**ADDENDUM NO. 2**

**SPLASH PAD RENOVATIONS**  
**(3% MBE PARTICIPATION GOAL)**

**May 21, 2026**

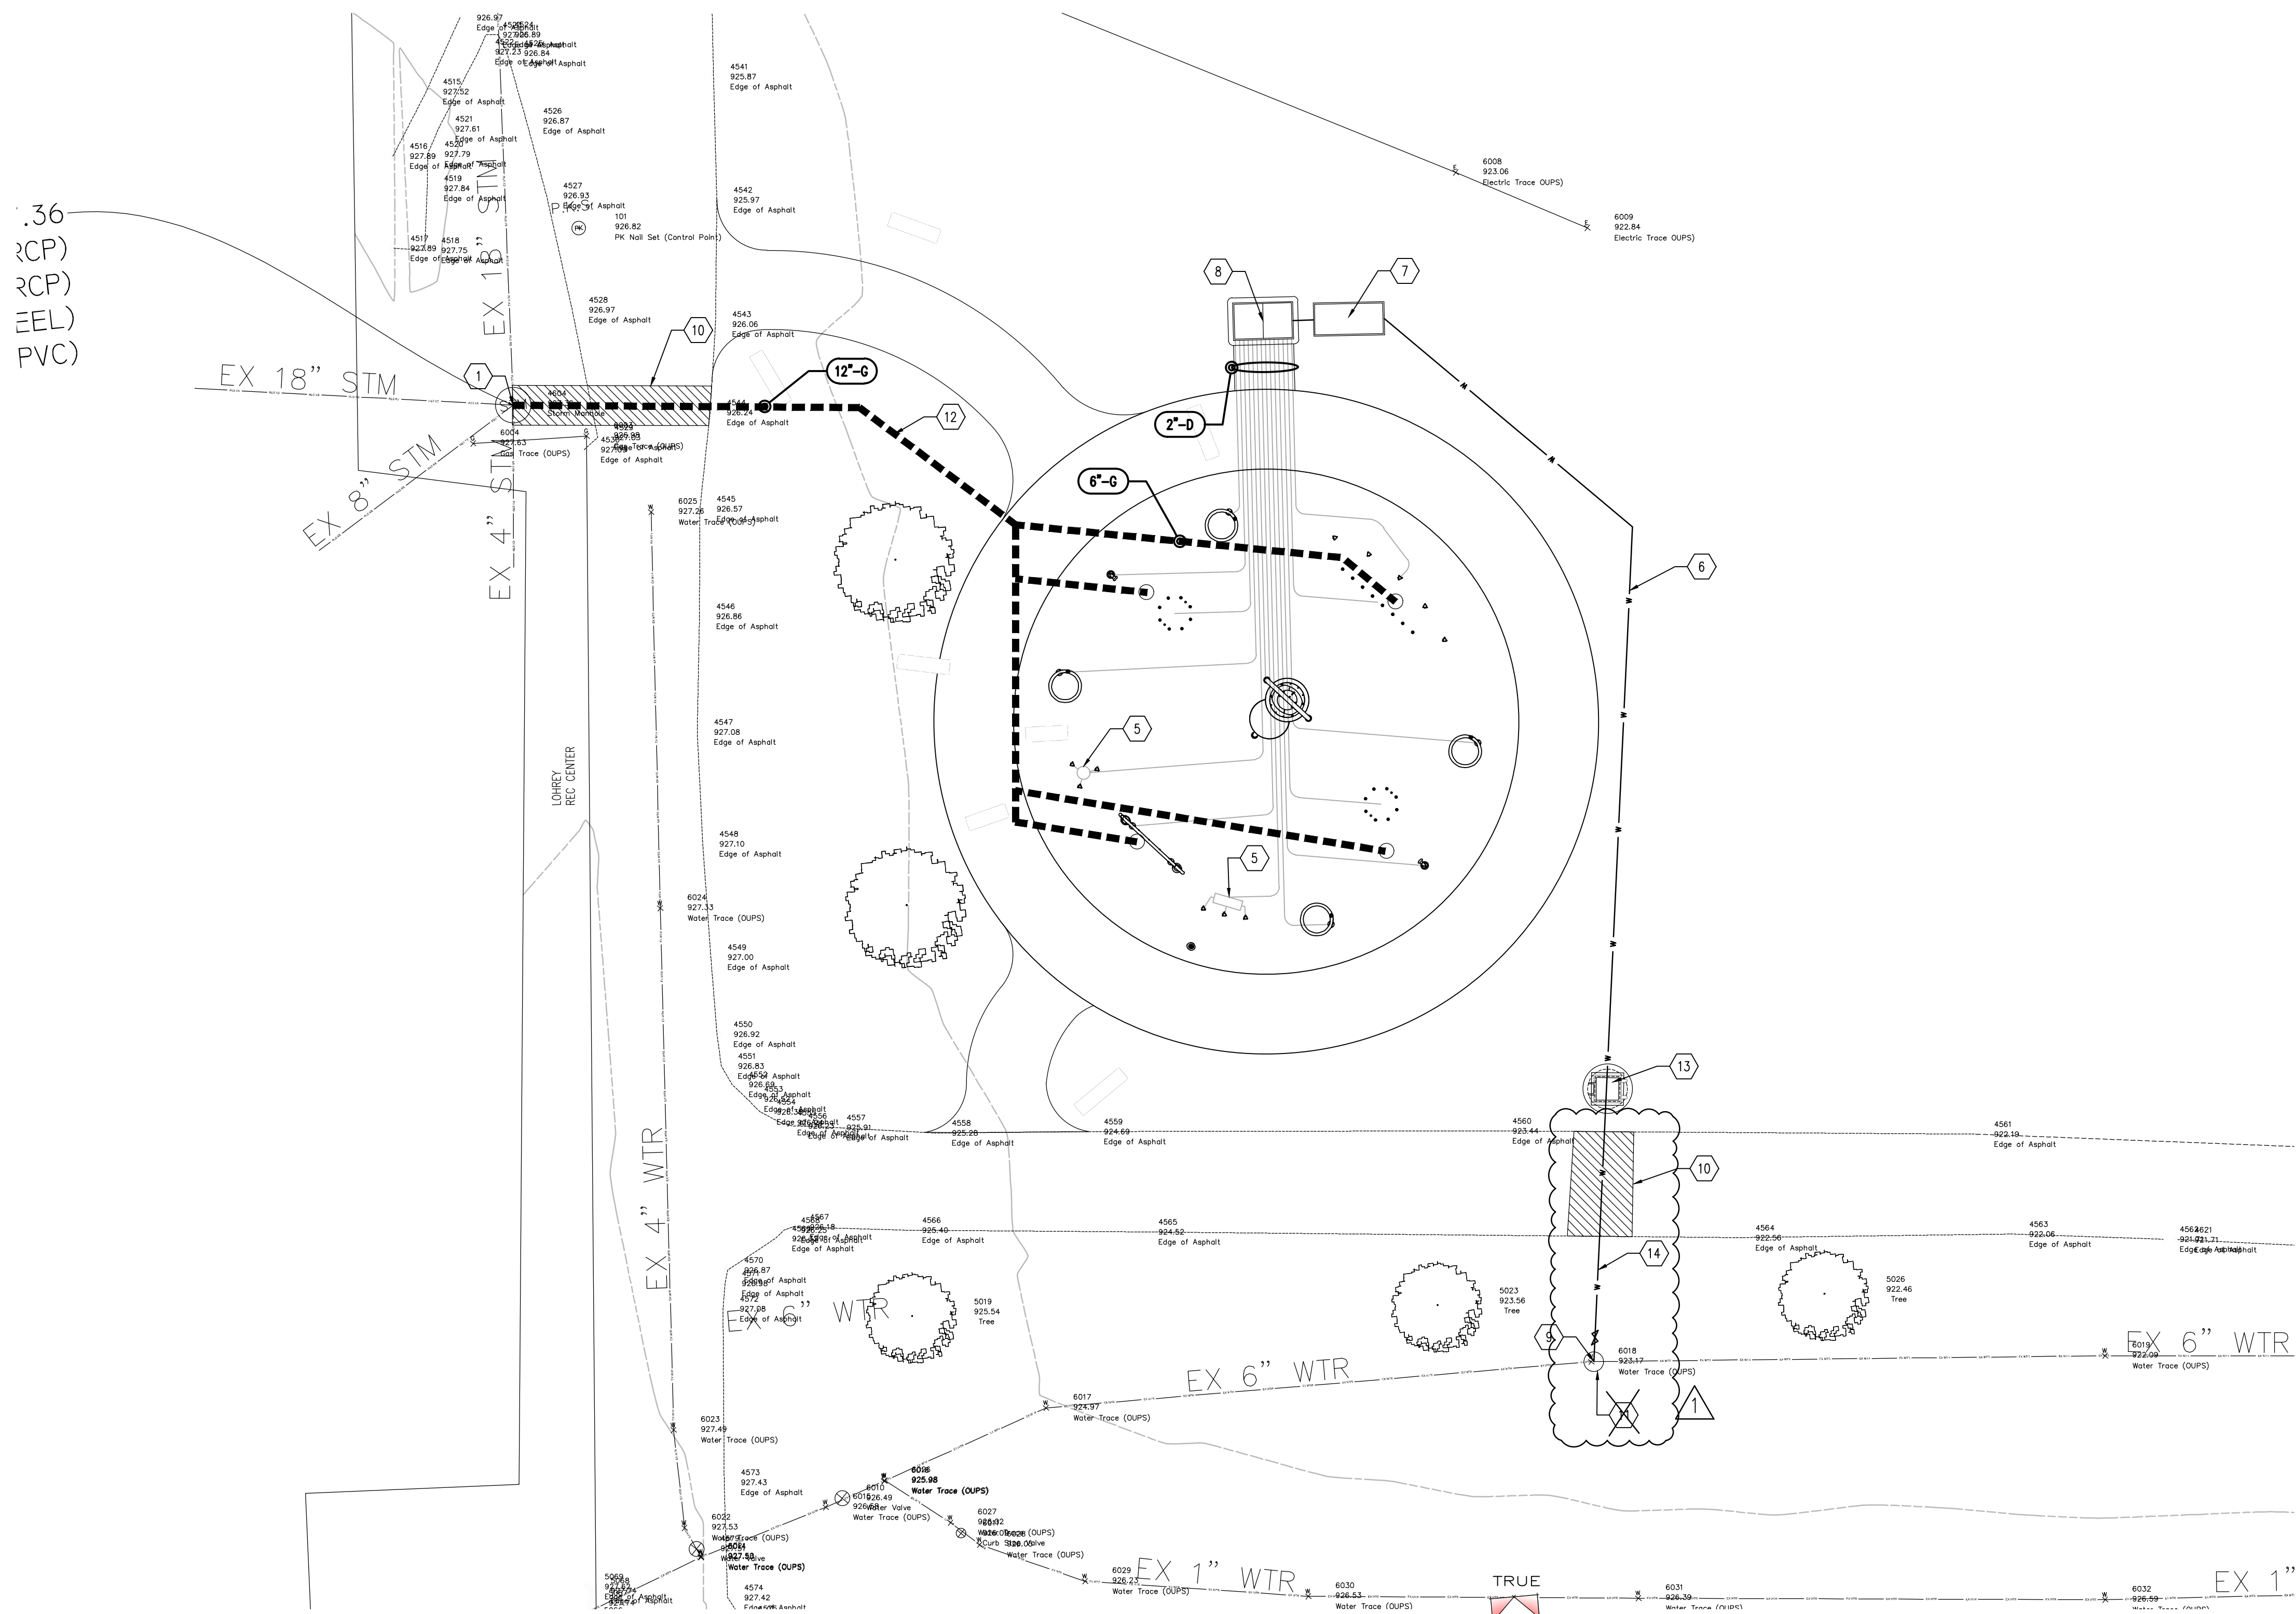
QUESTION #15: Page 111 of the specs, item 1.4C, it states there is hazardous material that were found. Is this accurate? If so, can you please provide the report from Justice Environmental?

ANSWER: This statement is to be disregarded. No hazardous materials are present as part of this project.
